Reviewed No Exceptions Noted ()
Reviewed Exceptions Noted (X)
Revise and Resubmit ()
Rejected ()

PROJECT TITLE:
WALLER CREEK
ITEM NUMBER:
GR-IF-120.1R
DESCRIPTION:
BENCH
SPECIFICATIONS:
MATERIAL: ST-01: PORTUGAL BEIGE LIMESTONE UP-120.1R: UPHOLSTERY
FINISH: STONE: HONED SURFACE CHISELLED SURFACE ALL SURFACES: MATTE PROTECTIVE SEALANT
NOTES:
JOB NO: 320C
DRAWN BY: MK/YA
DATE DRAWN: 6/25/2025
SCALE: AS NOTED
SHEET:

GR - IF - 120.1R
石头：葡萄牙米黄
加工：哑光面+自然边+防水
数量：9套

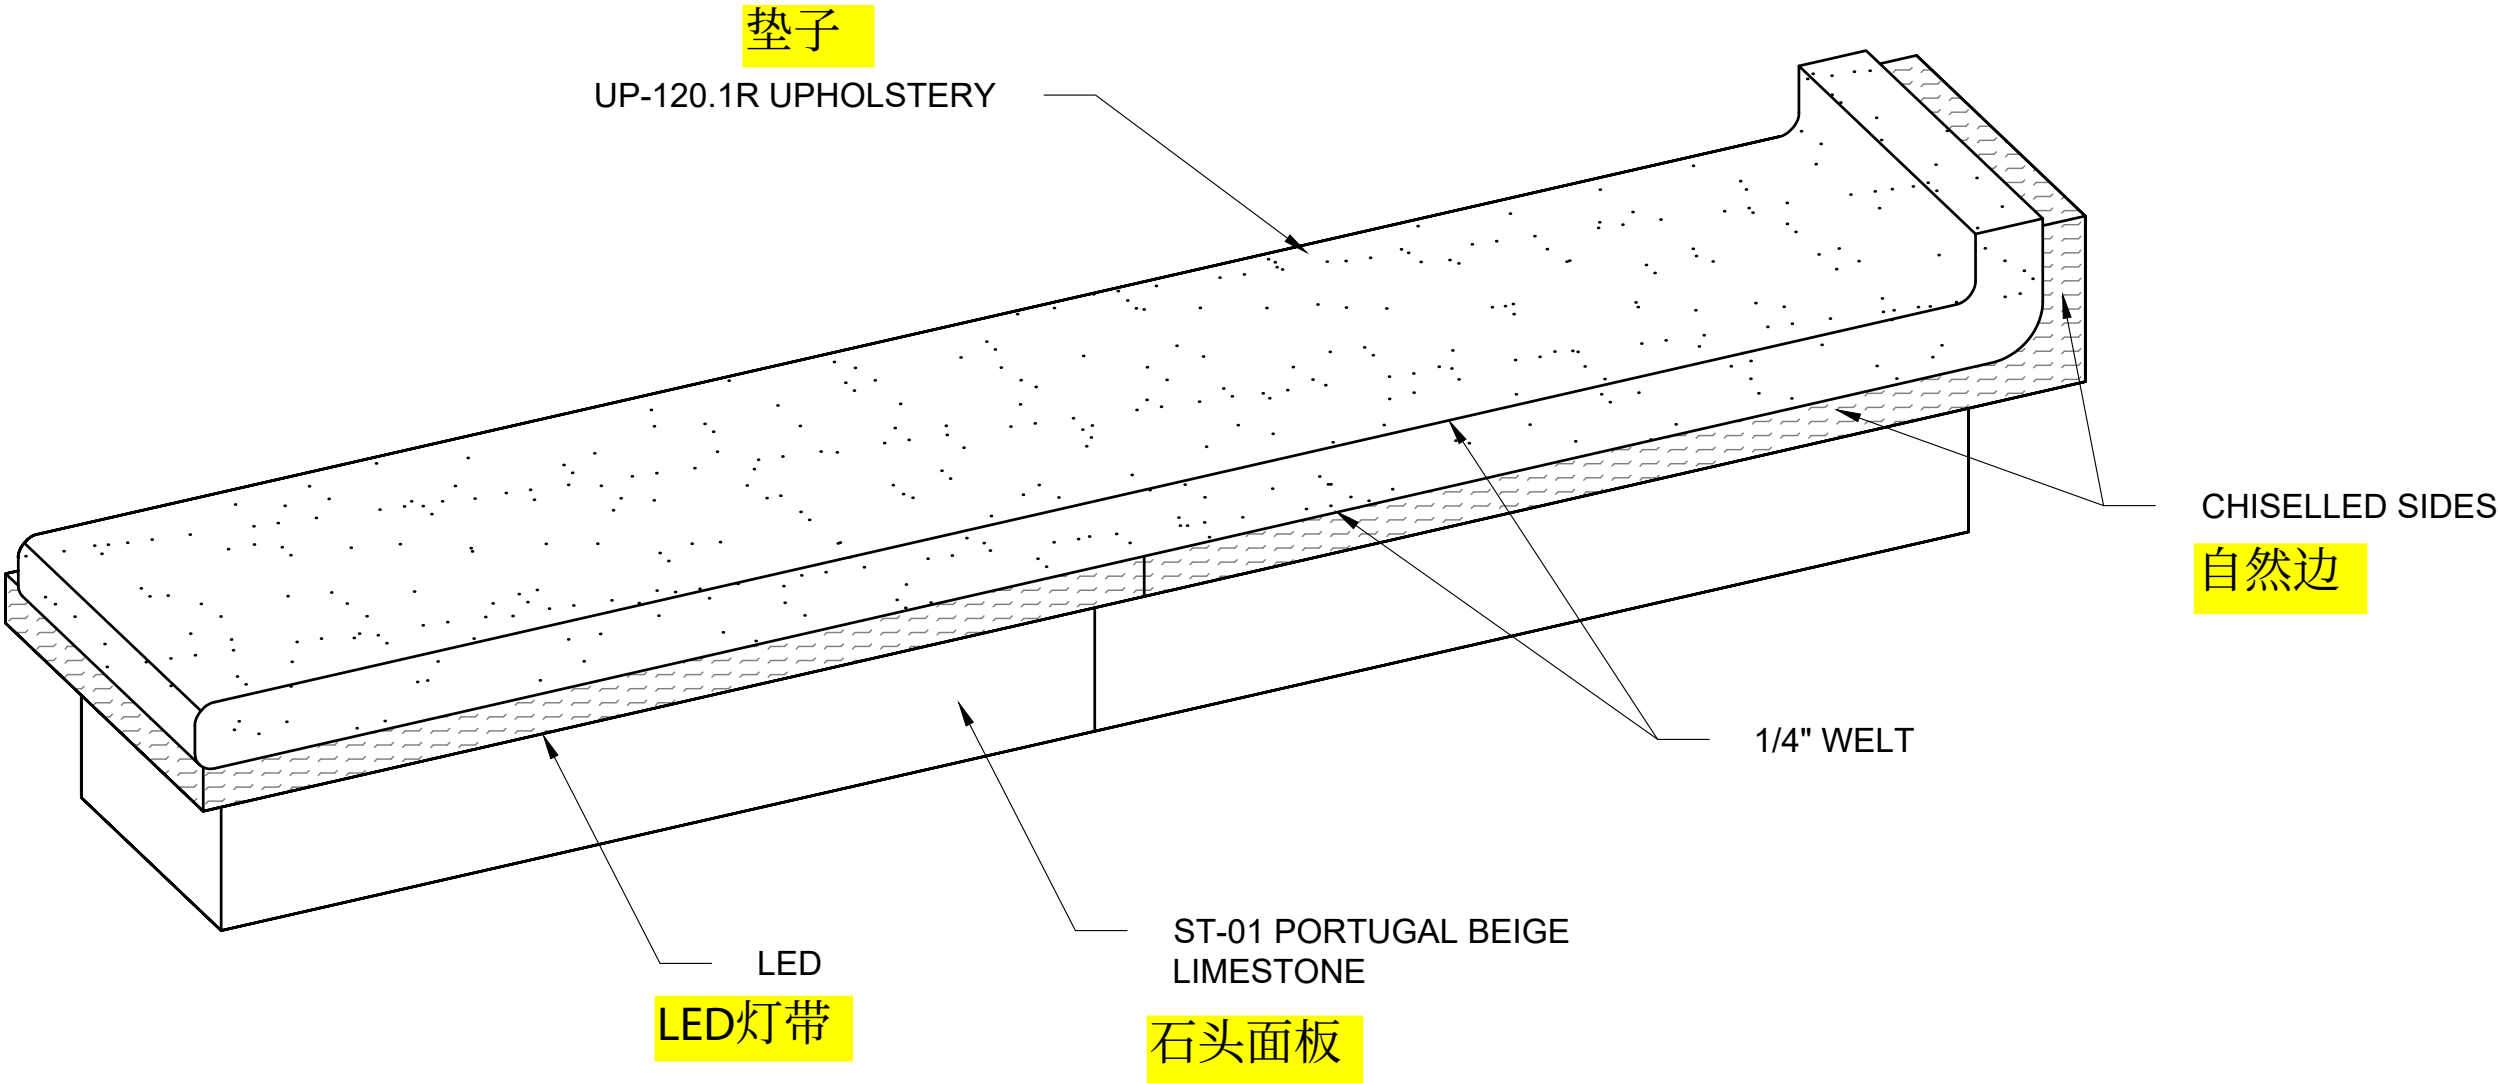
GENERAL NOTE
STUDY HEIGHT OF BENCH WITH TABLE AND CHAIR

GR - IF - 120.4
石头：葡萄牙米黄
加工：哑光面+自然边+防水
数量：6套

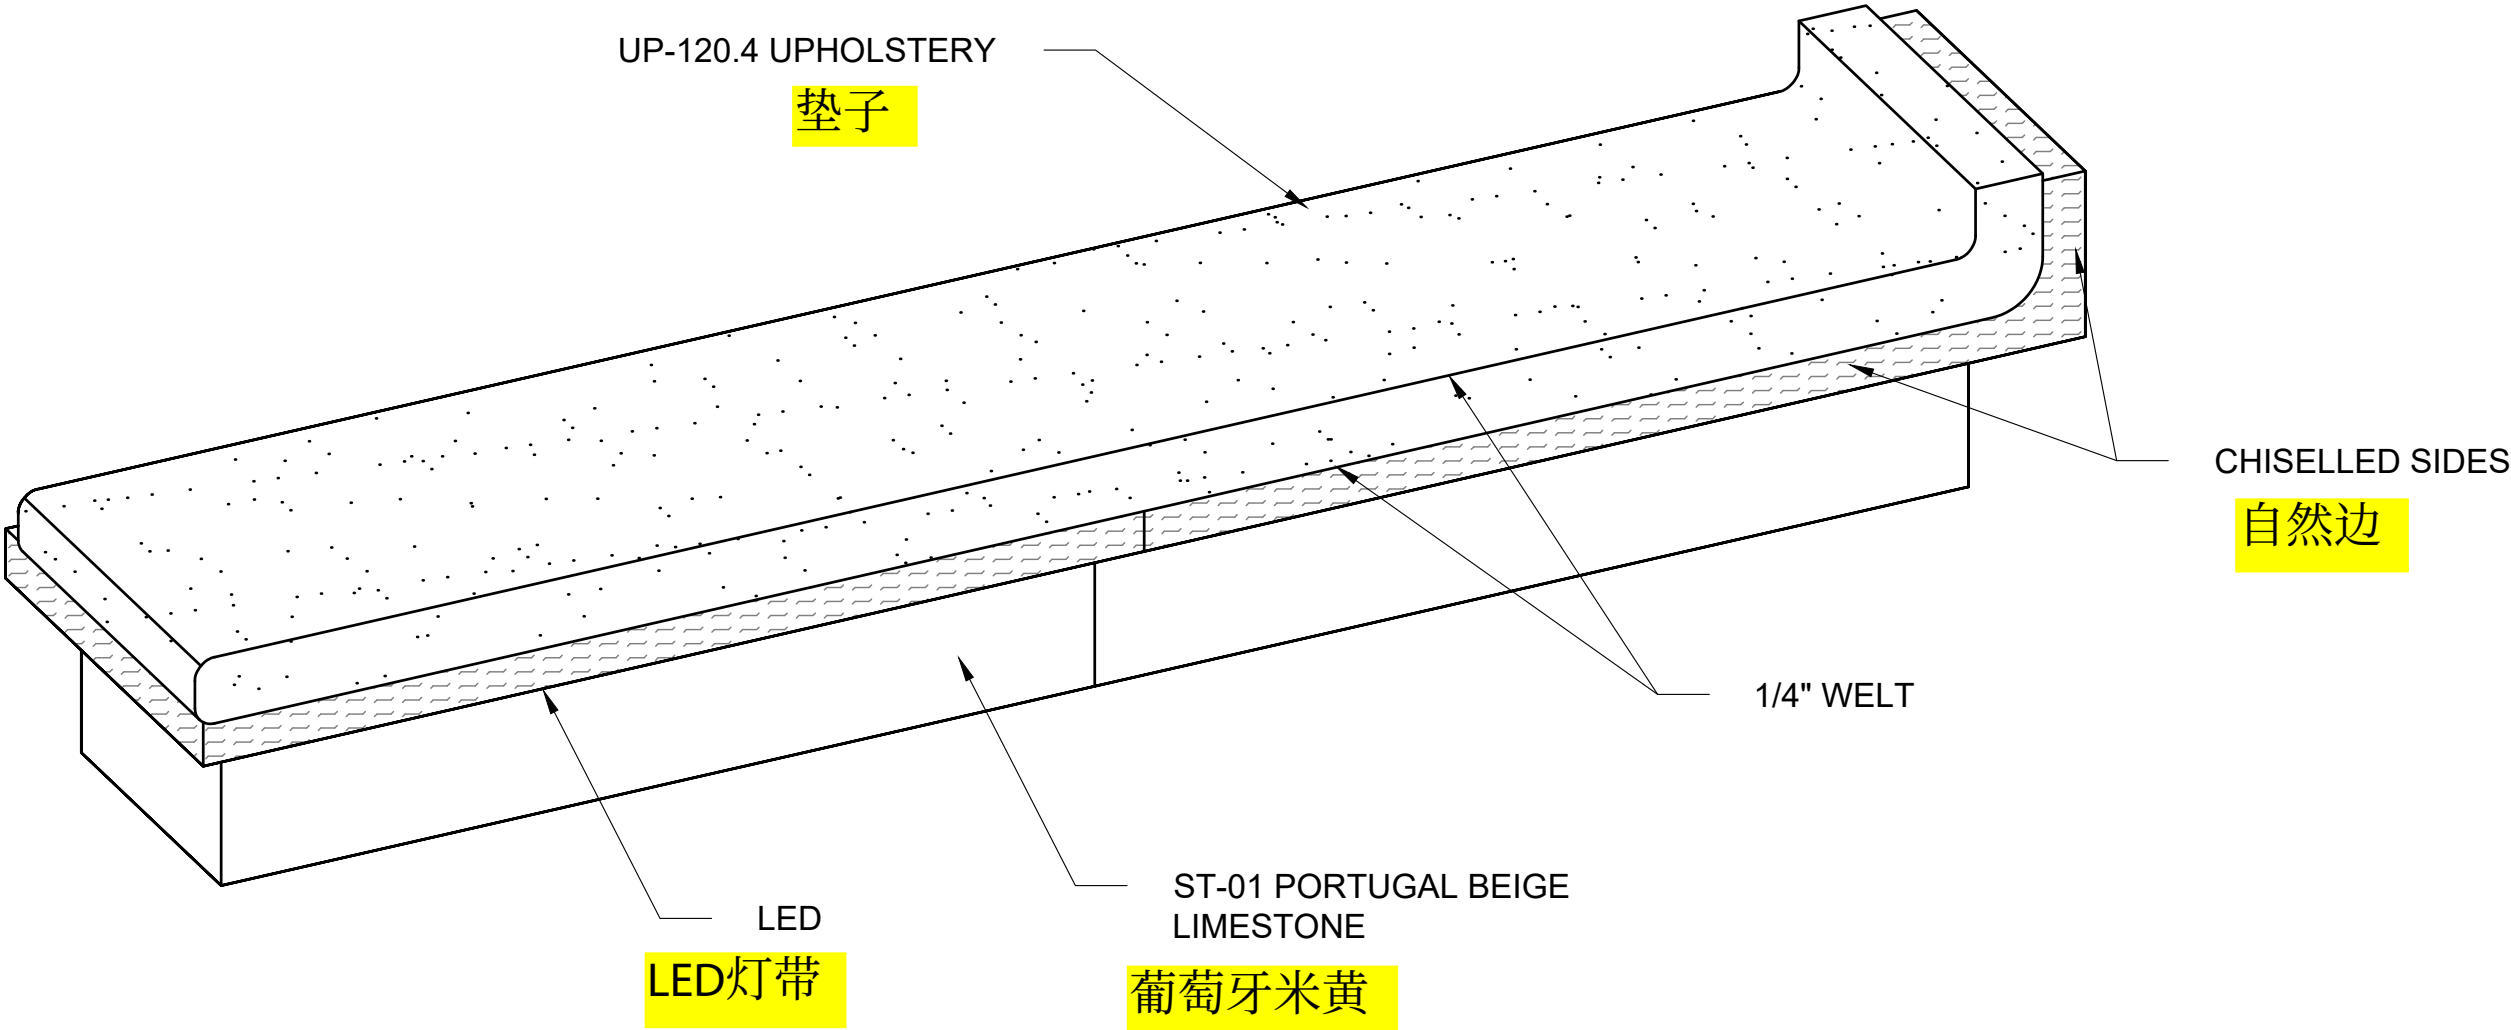
GENERAL NOTE
STUDY HEIGHT OF BENCH WITH TABLE AND CHAIR

Reviewed No Exceptions Noted ()
Reviewed Exceptions Noted (X)
Revise and Resubmit ()
Rejected ()

GR - IF - 120.5
石头：葡萄牙米黄
加工：哑光面+自然边+防水
数量：1套

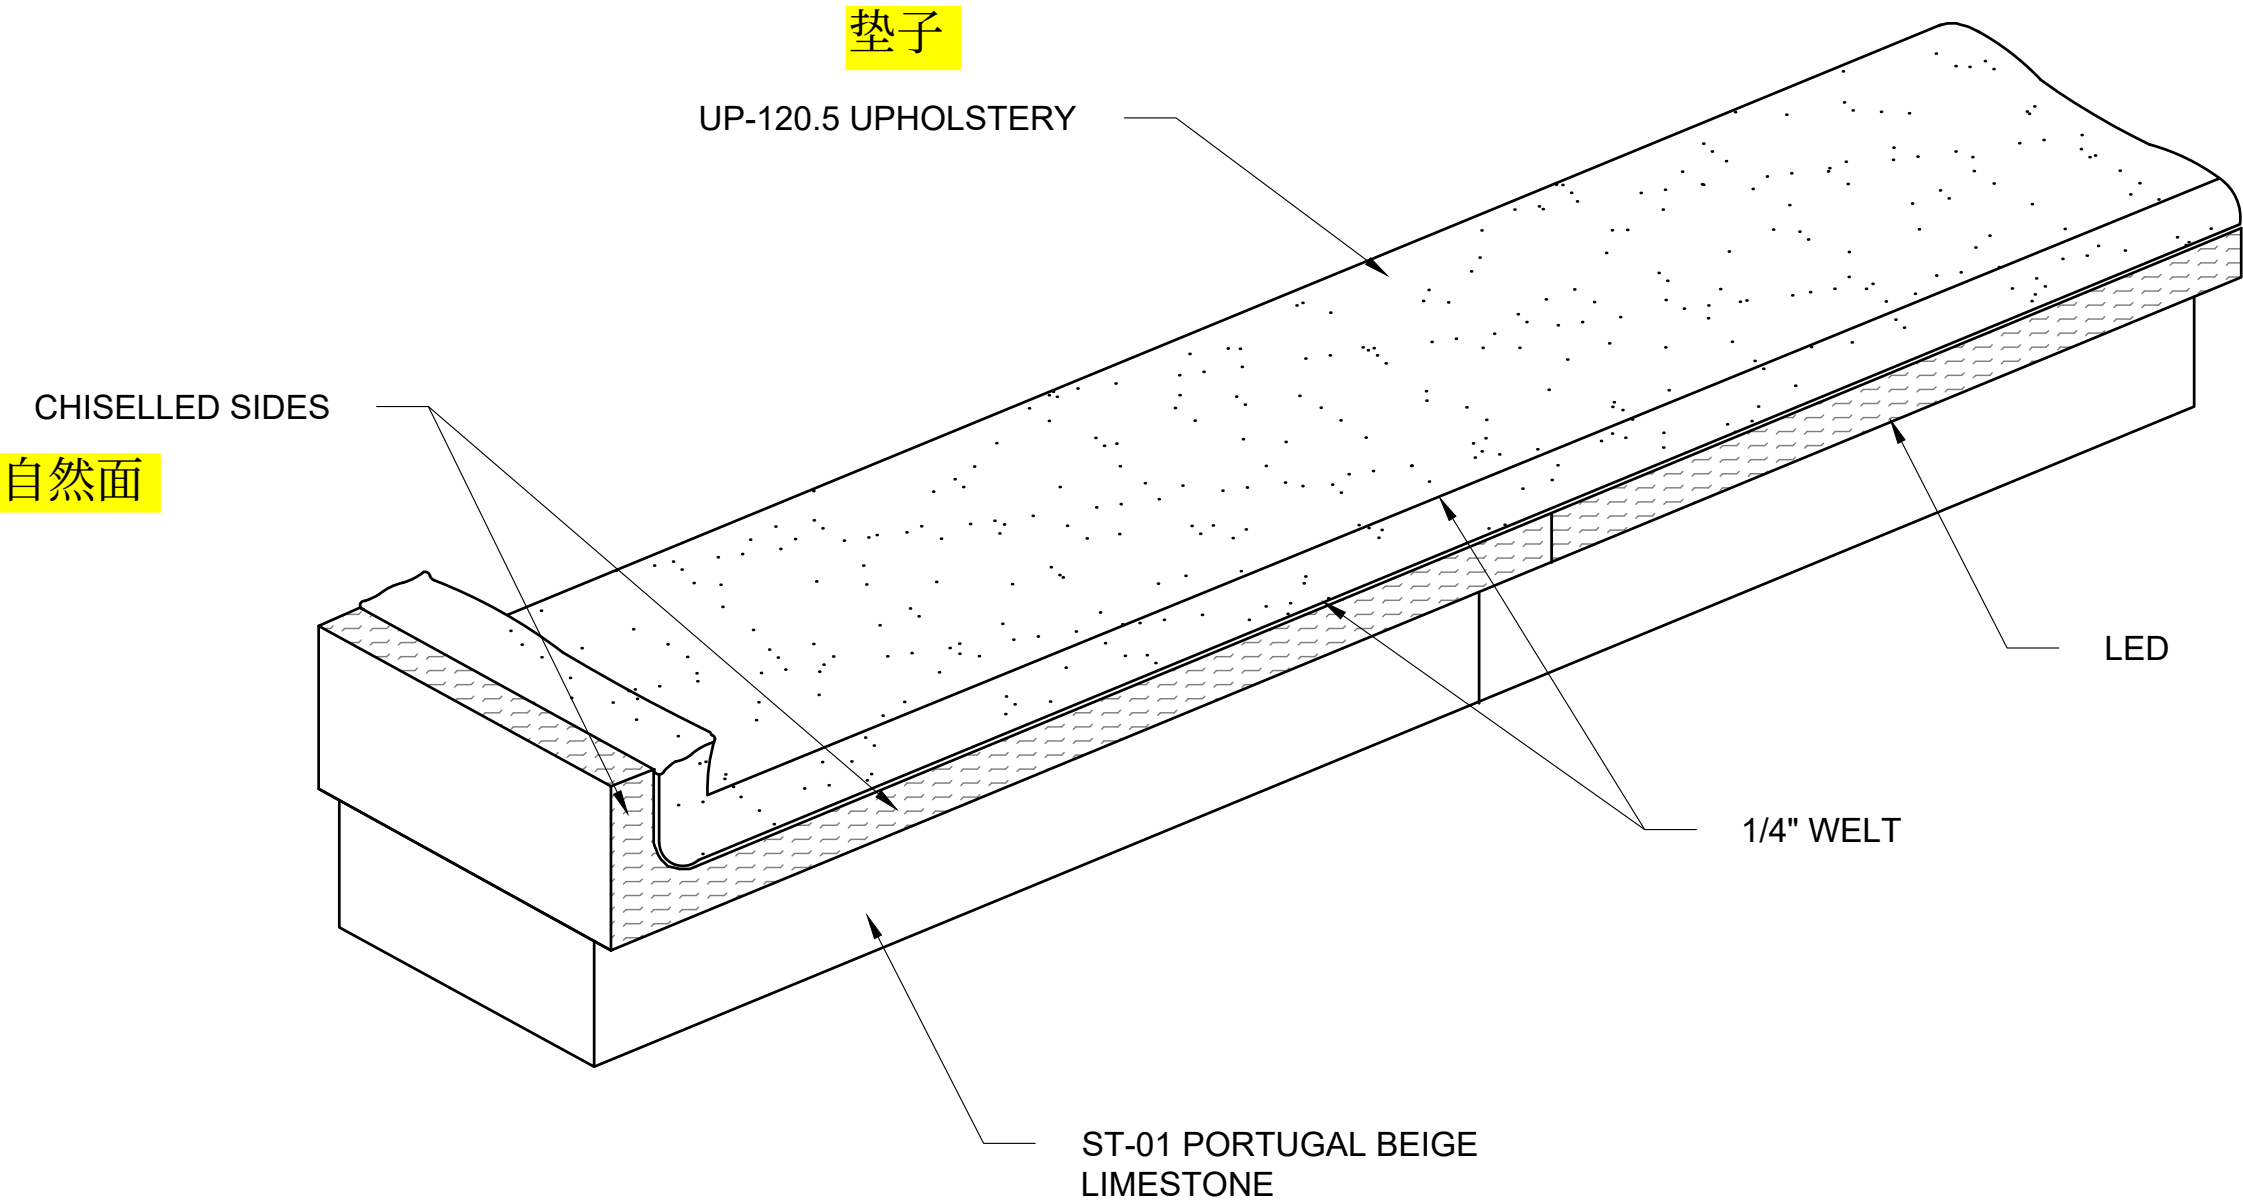
GENERAL NOTE
STUDY HEIGHT OF BENCH WITH TABLE AND CHAIR

Reviewed No Exceptions Noted ()
Reviewed Exceptions Noted (X)
Revise and Resubmit ()
Rejected ()

GR - IF - 120.6
石头：葡萄牙米黄
加工：表面哑光+自然这+防水
数量：2套

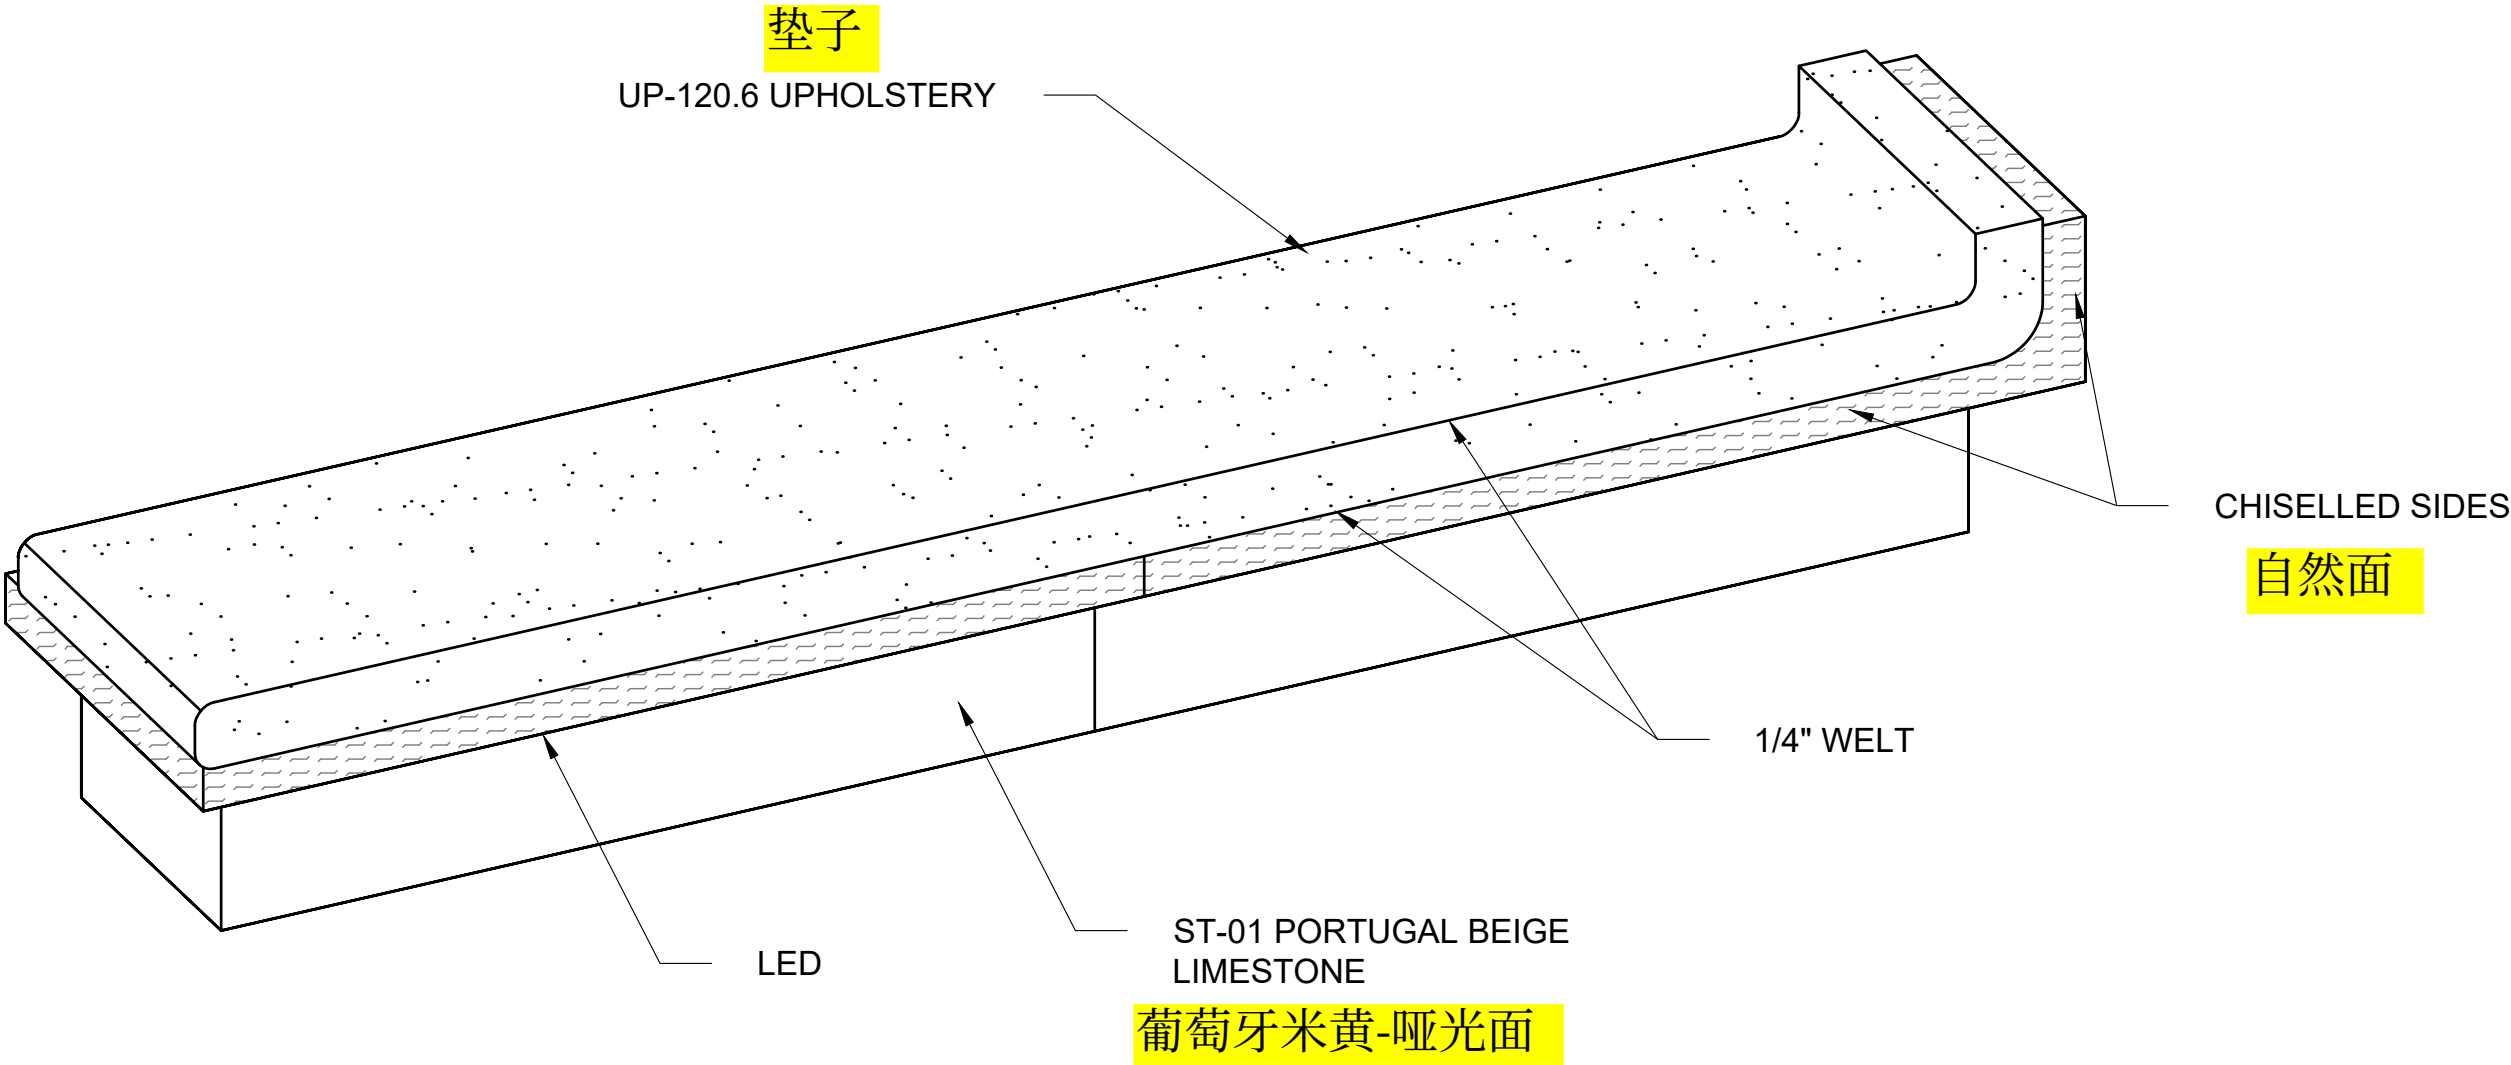
GENERAL NOTE
STUDY HEIGHT OF BENCH WITH TABLE AND CHAIR

Reviewed No Exceptions Noted ()
Reviewed Exceptions Noted (X)
Revise and Resubmit ()
Rejected ()
